ORE - TRAFFIC: Jan 2026 Proposed TEM Updates Summary

Each proposed revision (row below) is bookmarked in the document

TEM 298-42 Draft
Updated Figure(s)

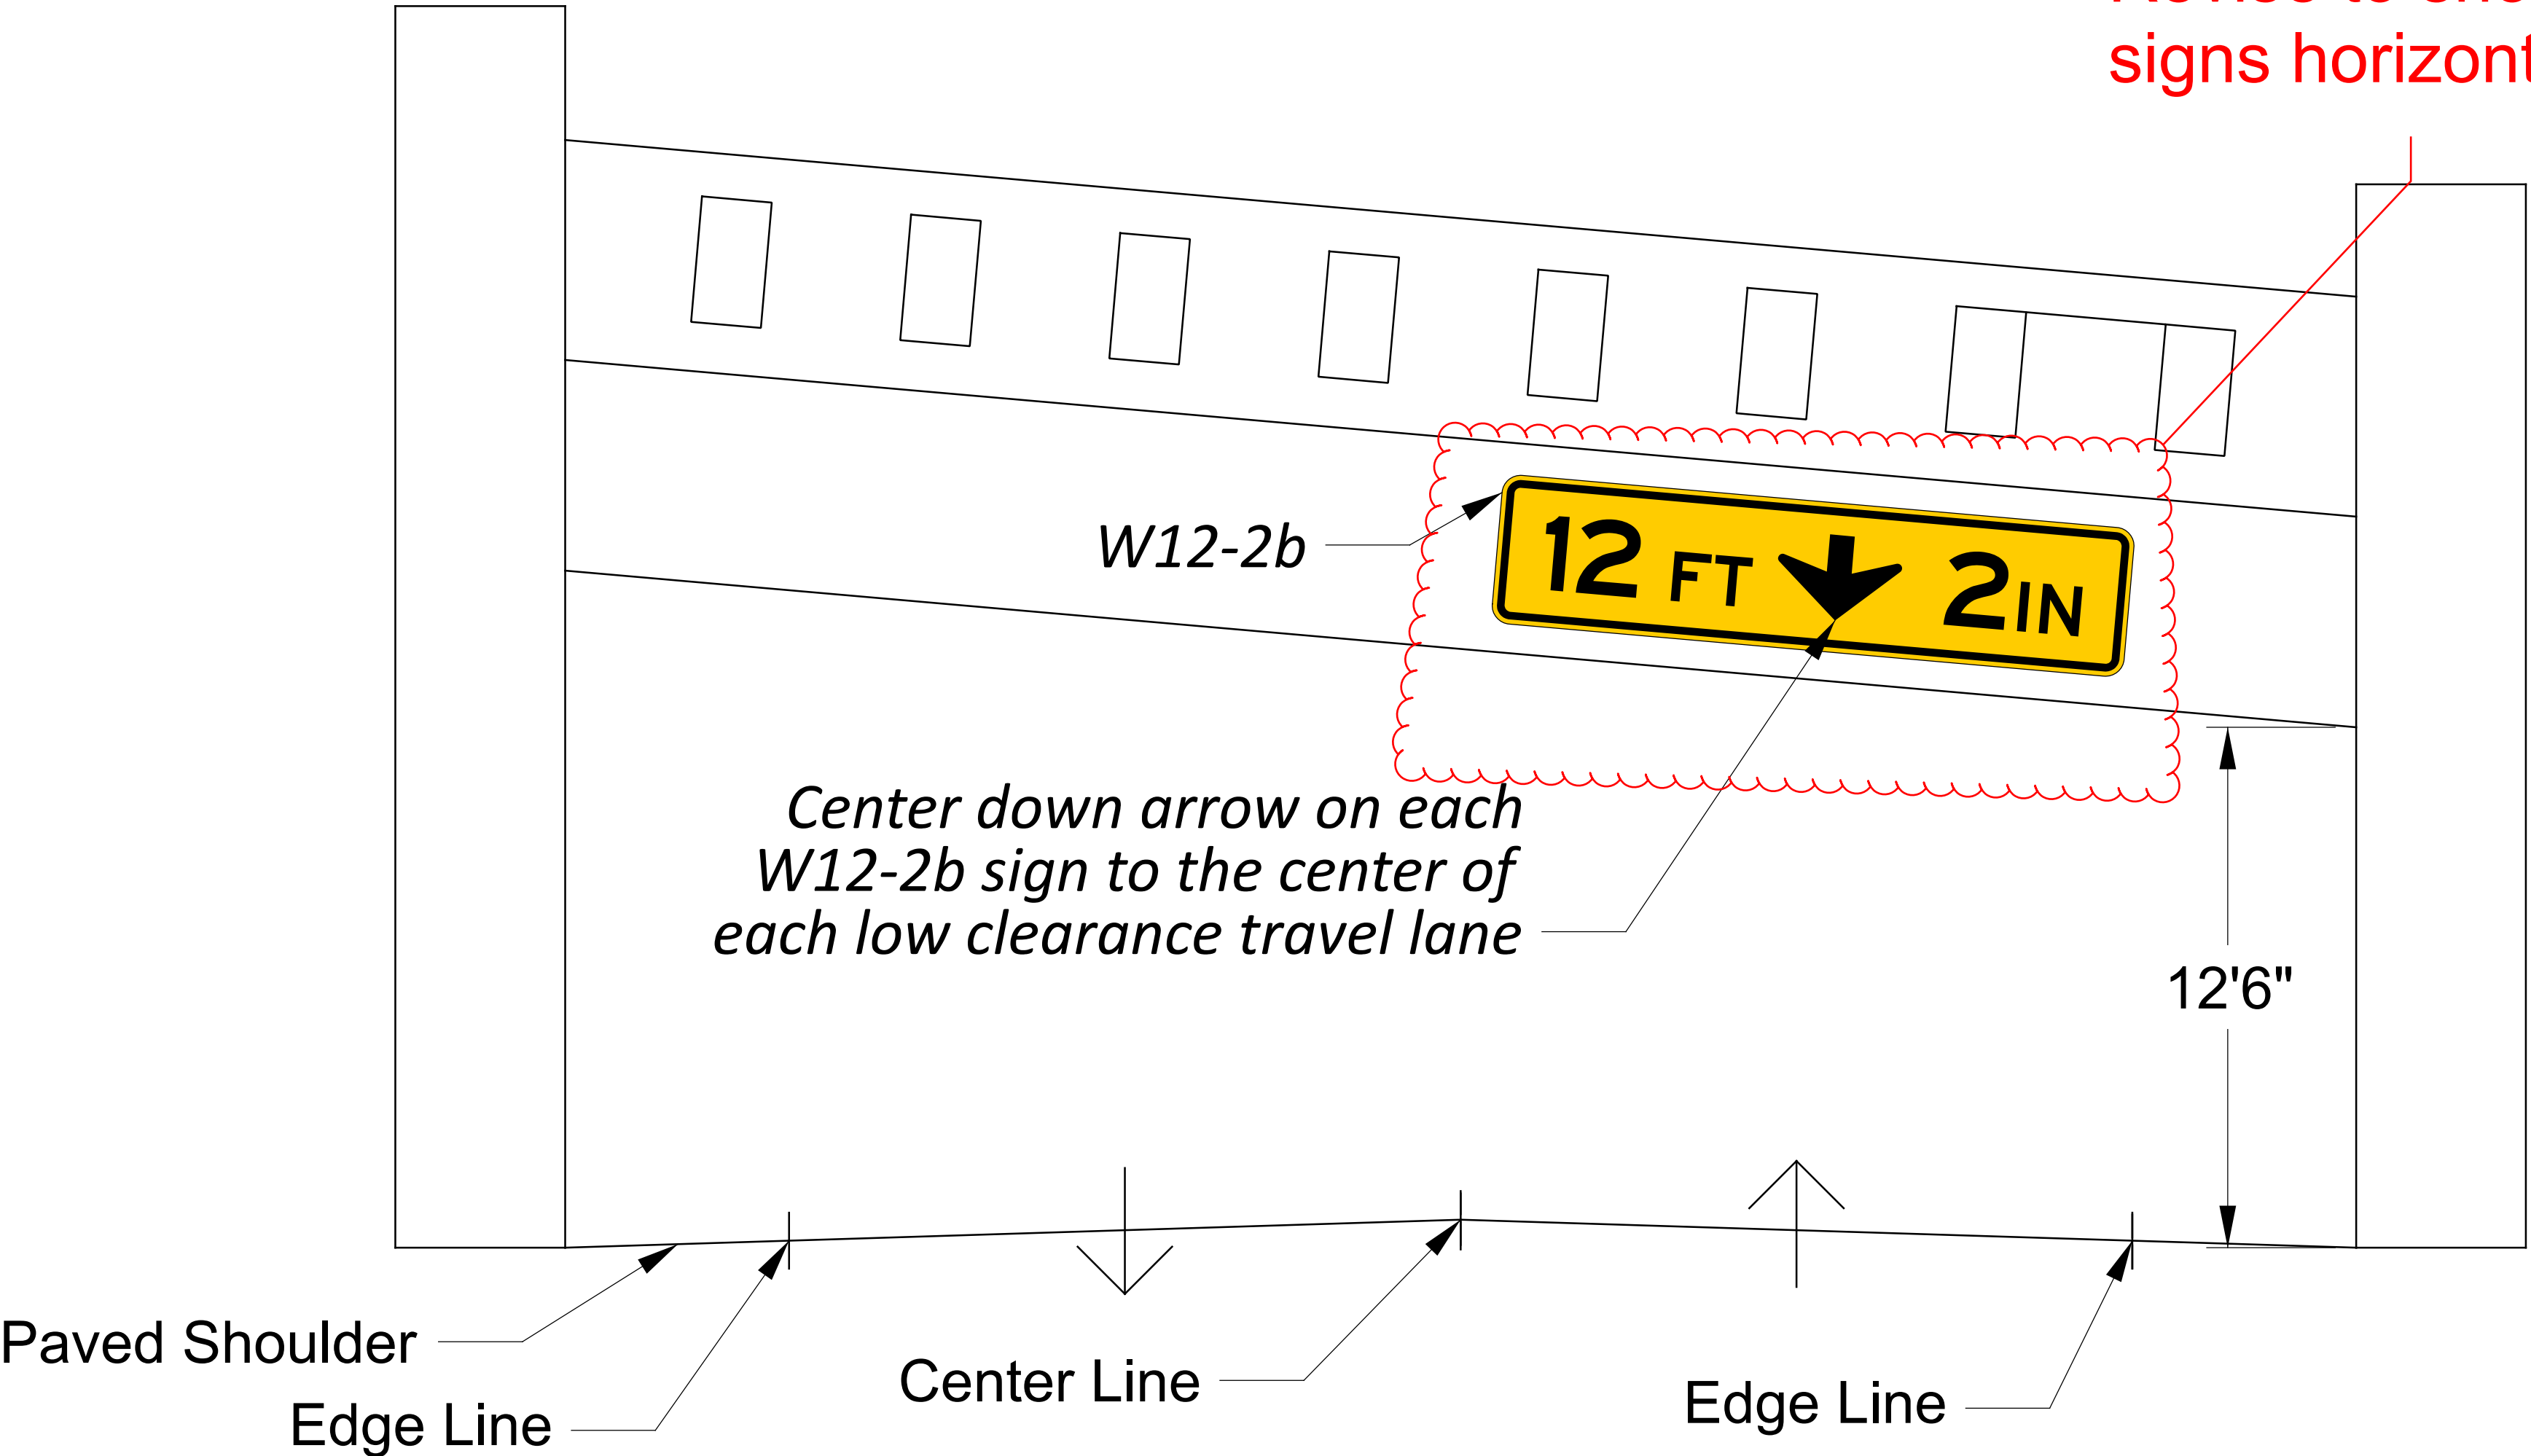
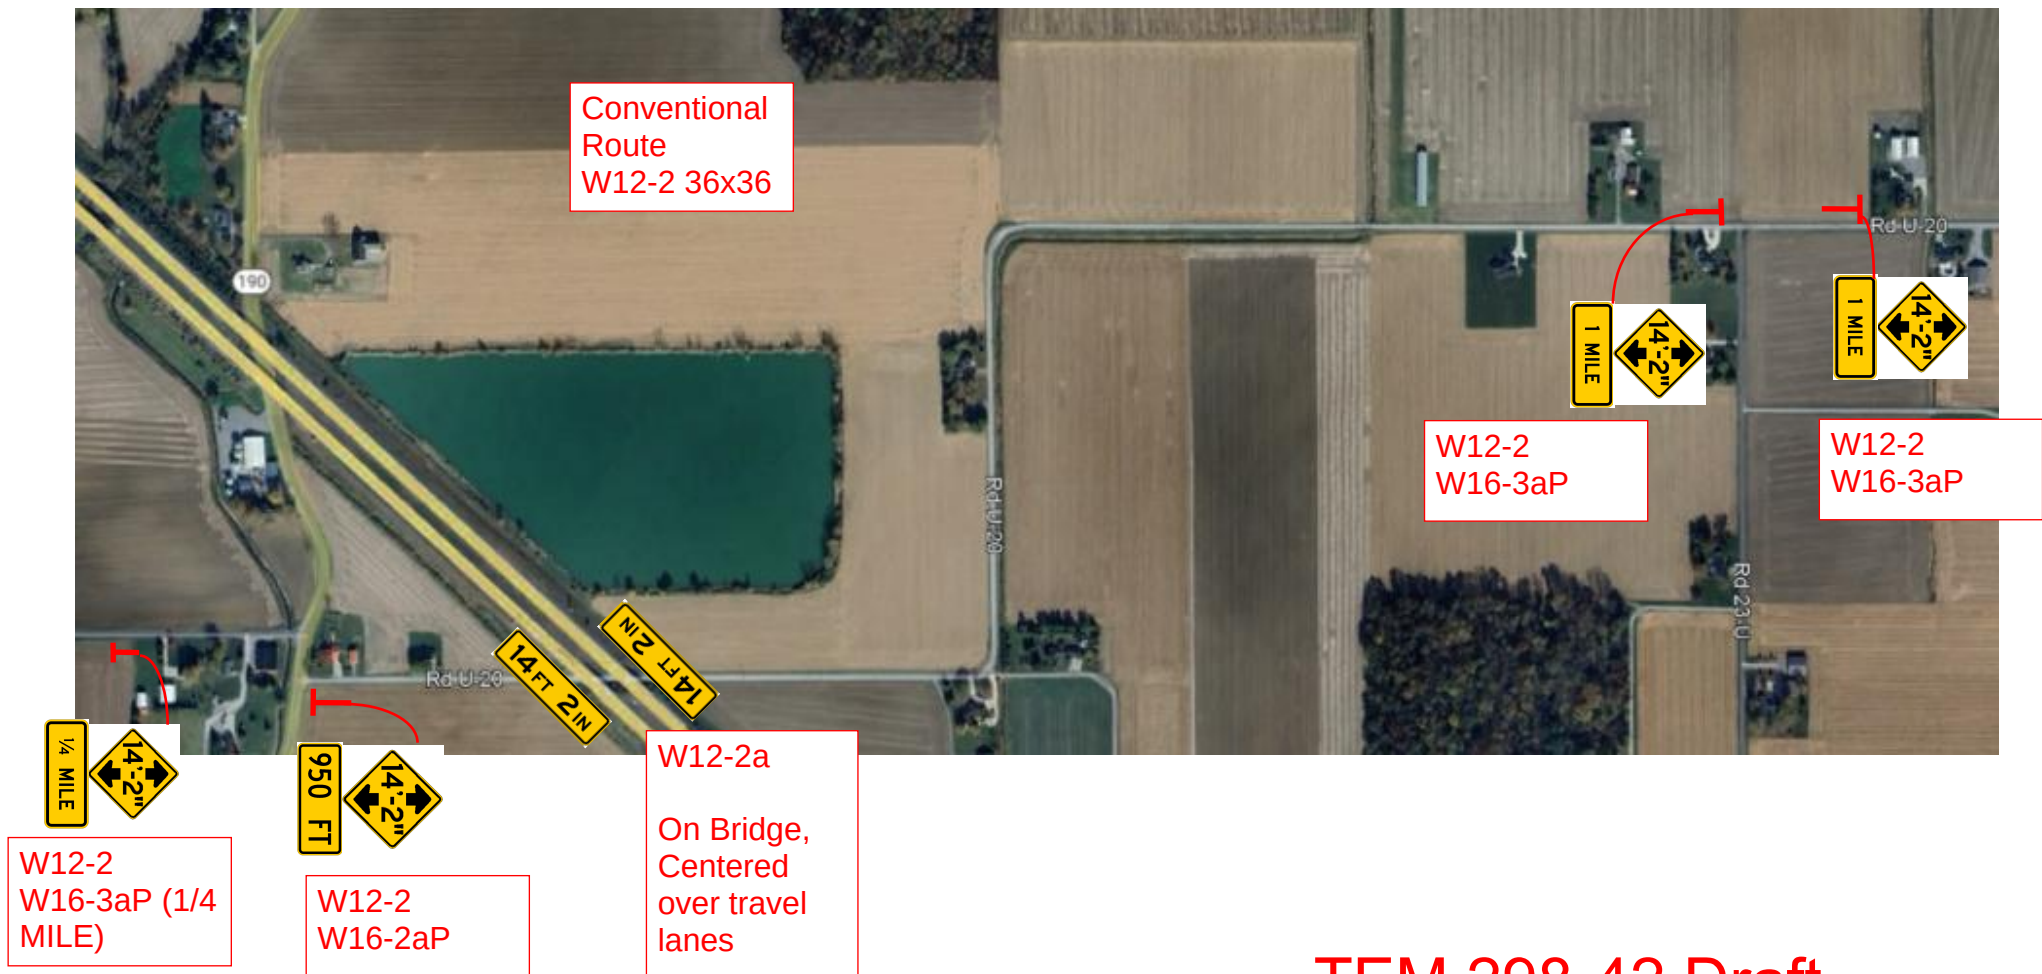
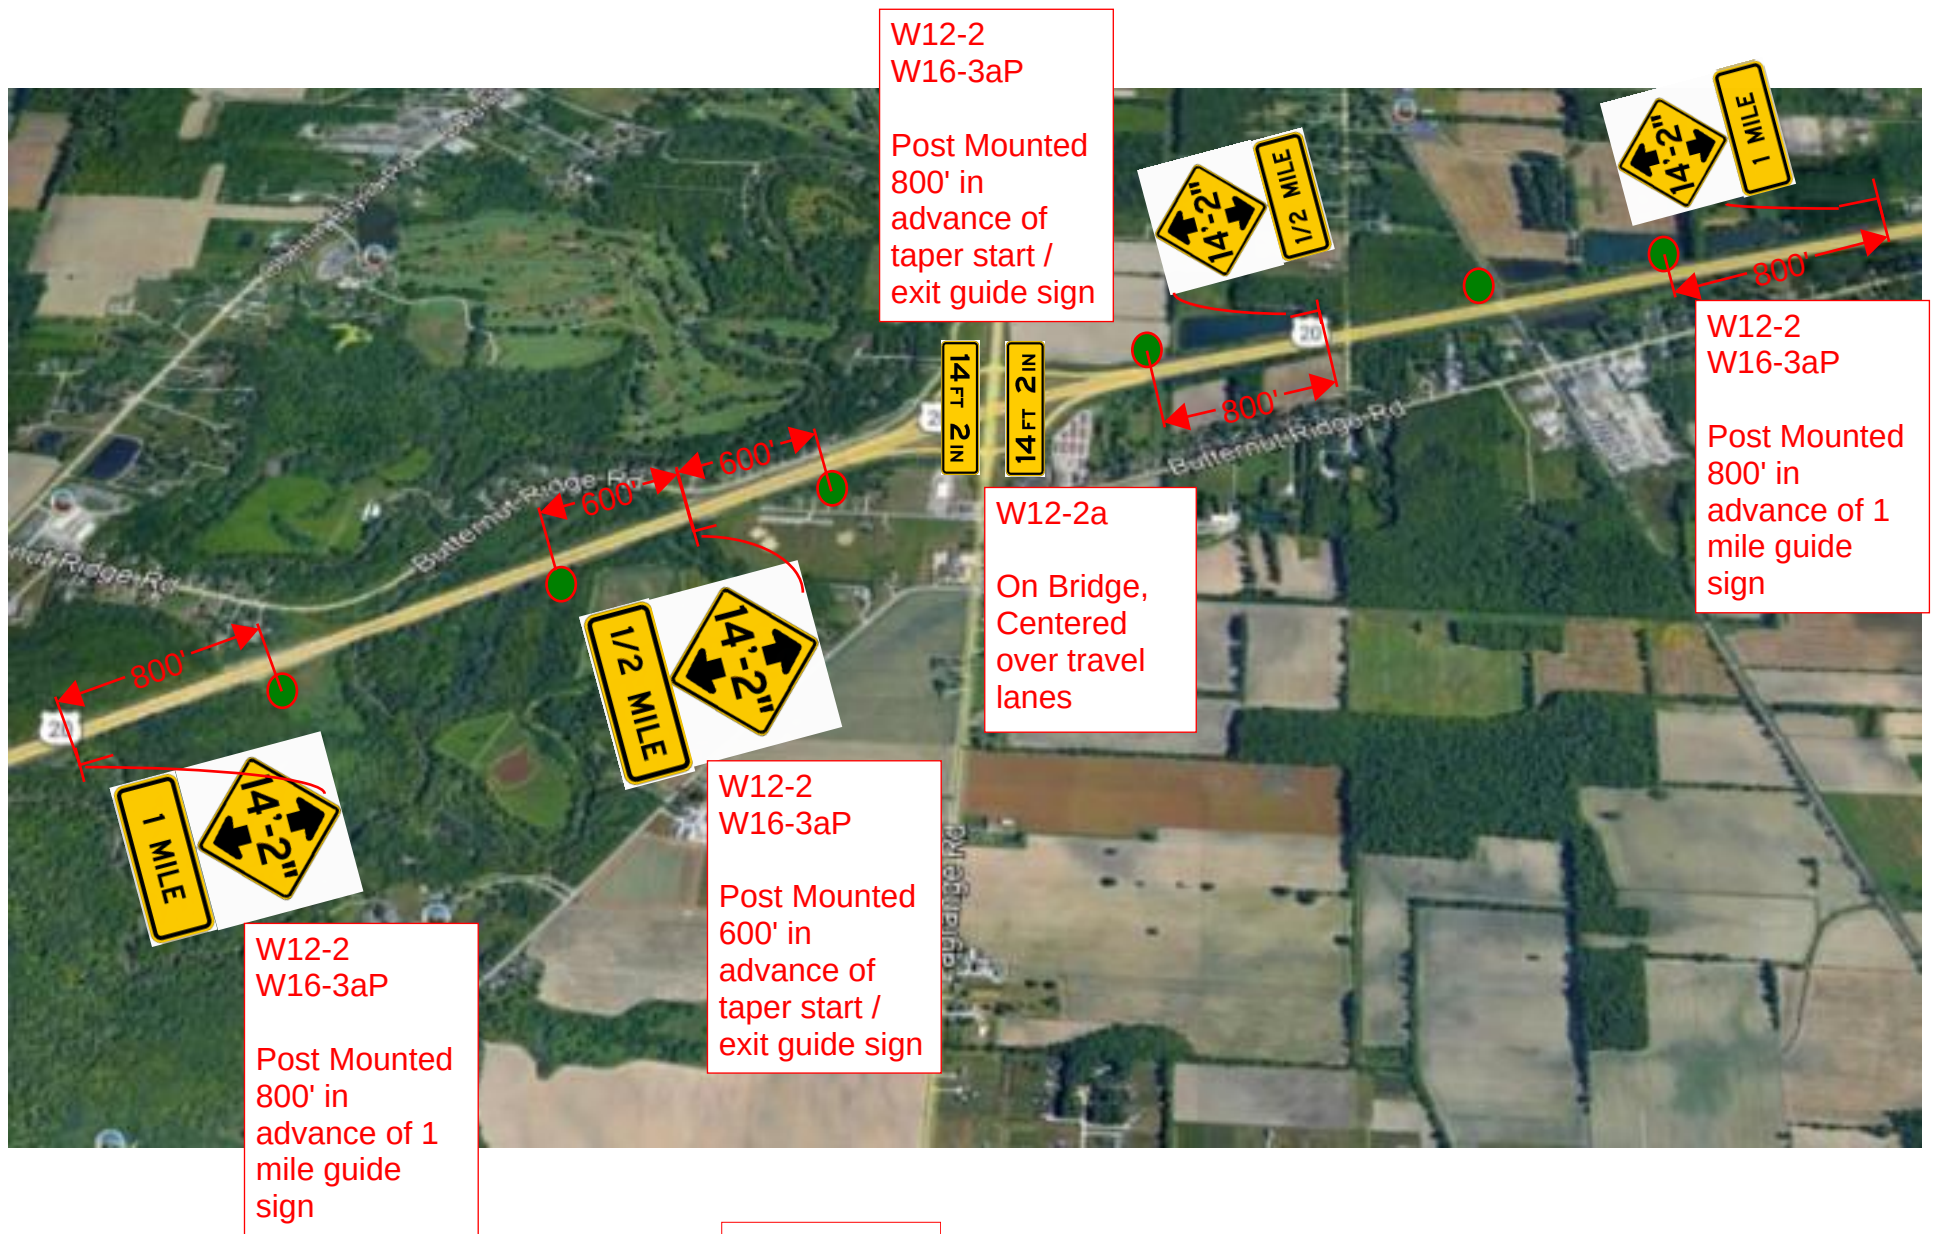
Revise to show
signs horizontal
